Project	<b>IEEE 802.16 Broadband Wireless Access Working Group</b> < <a href="http://ieee802.org/16">http://ieee802.org/16</a> >	
Title	<b>Proposed Modifications to the IEEE 802.16m SDD, Section 4</b>	
Date Submitted	<b>2008-03-10</b>	
Source(s)	Yair Bourlas Lei Wang Ramon Khalona	Voice: E-mail: <a href="mailto:ybourlas@nextwave.com">ybourlas@nextwave.com</a>

# Proposed Modifications to the IEEE 802.16m SDD, Section 4

Figure 1 Example of overall network architecture

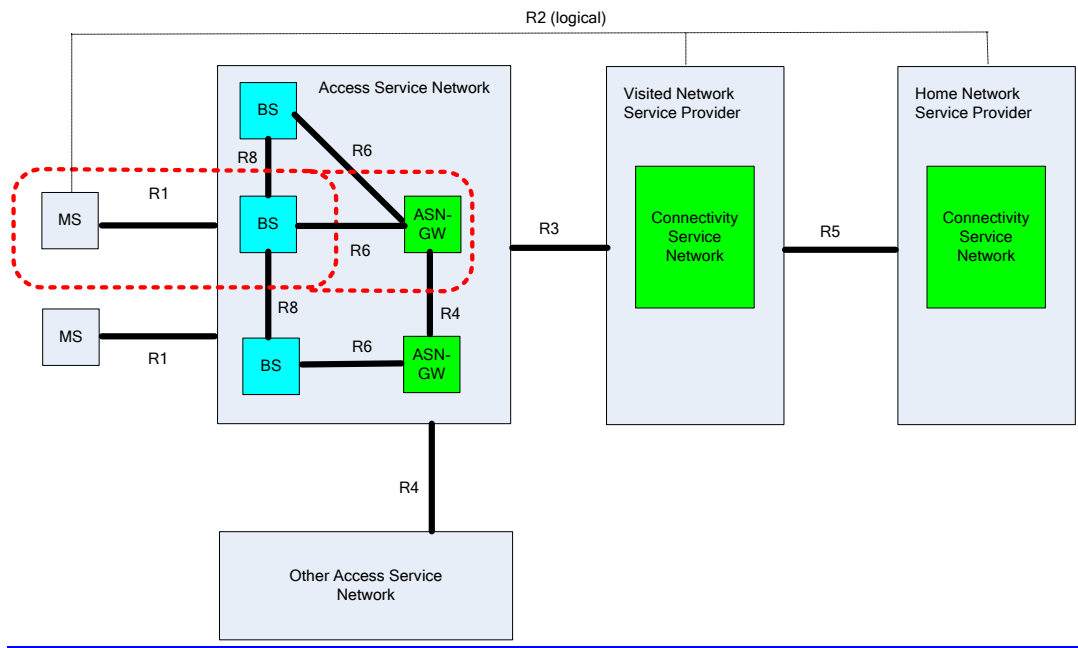
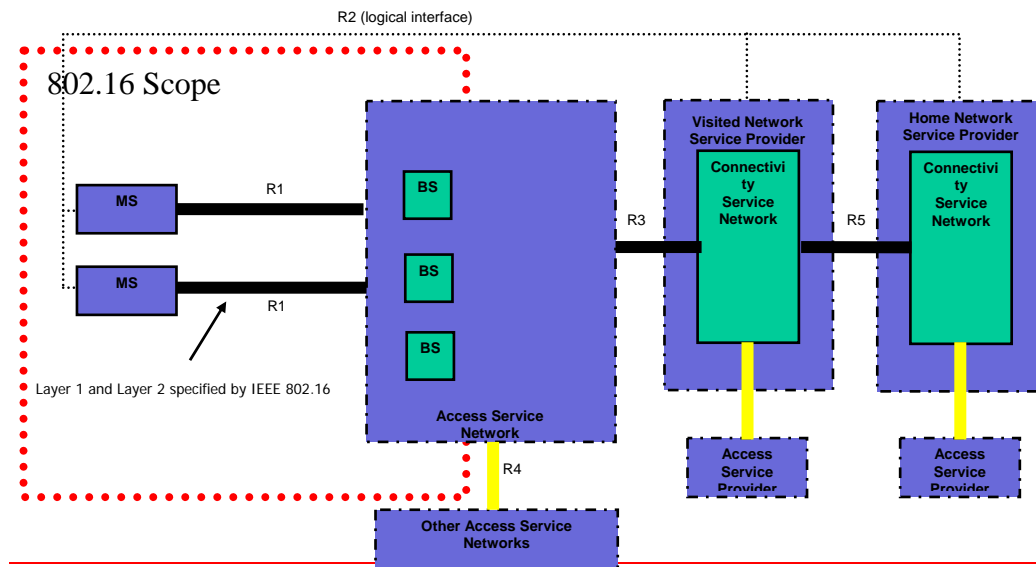
- Section 4
  - The Network reference model is WiMAX release 1.0 centric. WiAMX is evolving its network reference model. We believe that 802.16m needs to adopt longer term view which allows for future evolution of WiMAX network reference model

This section describes the Network Reference Model (NRM) as being developed in the WiMAX Network Working (NWG) group. The existing network reference model is defined in WiMAX Network Architecture [9] for Release 1.0 supported features. The NRM is being evolved to support R1.5 features such as E-911, Location Based Services, Simple IP support, and MCBCS [cite NWG reference to R1.5 documents].

The NRM is a logical representation of the network architecture. The NRM identifies functional entities and reference points over which interoperability is achieved between functional entities. The following Figure 1 illustrates the NRM, consisting of the following logical entities: Mobile Station (MS), Access Service Network (ASN), and Connectivity Service Network (CSN). The dotted red line denotes IEEE 802.16m scope. The ASN comprises network elements such as one or more Base Stations (BS), and one or more ASN Gateway (ASN-GW) nodes and is

~~The existing network reference model is defined in WiMAX Network Architecture [9].~~
